Access Compliance Report Public Rights-of-Way (Curb Ramps)

Main Street: BRAE_GLEN Cross Street: CRAWFORD_CANYON_RD Location: NW

ADA ID: RPRK211007172336 Ramp Type: Type 1 - Perpendicular Diagonal Initial Pass/Fail: Pass Overall Compliance: No Severity Score: 28

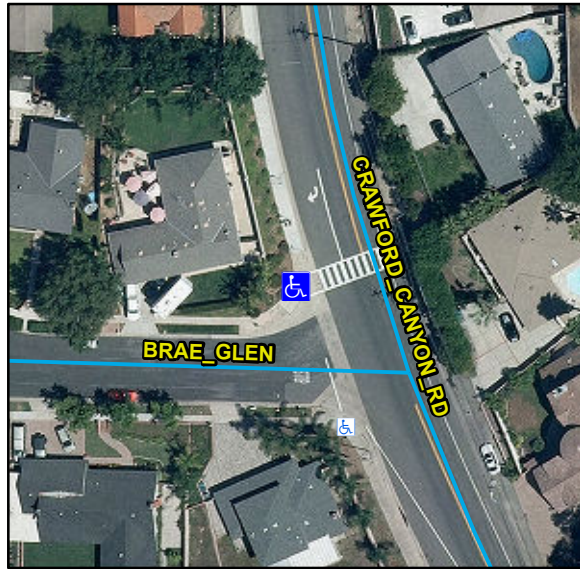
Remove & Replace Curb Ramp With Two New Directional Ramps or Equivalent. Restripe Crosswalk. Remove & Replace Gutter.

R304.2.2, R204.3, R304.2.1, R304.2.2-Perp, R304.3.2-Para, R304.5.3, R304.2.3, R305, R207.1, R304.5.4, STD 1115

Compliance	Description	Data	Compliance	Description	Data
N/A	Ramp Length (in)	79	N/A	Flare Type LT	
Yes	Ramp Width (in)	48			Sloped
Yes	Ramp Run Slope (%)	8.3	No	Flare Slope LT (%)	11.4
Yes	Ramp Cross Slope (%)	1.9	N/A	Flare Traversable LT	Yes
N/A	Landing Present	No	N/A	Flare Type RT	
N/A	Landing Length (in)	N/A			Sloped
No	Landing Width (in)	N/A	Yes	Flare Slope RT (%)	9.8
No	Landing Run Slope (%)	N/A	N/A	Flare Traversable RT	Yes
No	Landing Cross Slope (%)	N/A	No	DWS Provided	No
N/A	Landing Movement Obstructed?	Yes	N/A	DWS Contrast	N/A
	Landing Movement Type	Curb	N/A	DWS Length (in)	N/A
N/A	Landing Shared	N/A	N/A	DWS Full Width	N/A
N/A	Clear Space	Yes	N/A	DWS Offset Left (in)	N/A
N/A	Clear Space To Crosswalk (in)	48	N/A	DWS Offset Right (in)	N/A
N/A	Marked Crosswalk 1	No	N/A	Marked Crosswalk 2	Yes
	Crossing 1 Direction	S		Crossing 2 Direction	E
	Marked Crosswalk 1 Width (in)	N/A		Marked Crosswalk 2 Width (in)	144

N/A	Ramp Inside Crosswalk 1	N/A	Yes	Ramp Inside Crosswalk 2	No
	Crossing 1 Slope (%)	8.1		Crossing 2 Slope (%)	1.7
	Crossing 1 Cross Slope (%)	5.3		Crossing 2 Cross Slope (%)	1.4
Yes	Gutter Ponding	No	No	Curb Slope	11.8
Yes	Gutter Lip Height (in)	0		Road Run Slope (%)	4.8
No	Gutter Run Slope (%)	6		Road Cross Slope (%)	0.1
No	Gutter Cross Slope (%)	4.2			
Yes	Overall Surface Condition: Acceptable		No	Perp Joint Present	No
	Cross Gutter Present?	Yes		Spandrel Present?	Yes
	Replace Cross Gutter?	No		Replace Spandrel?	No
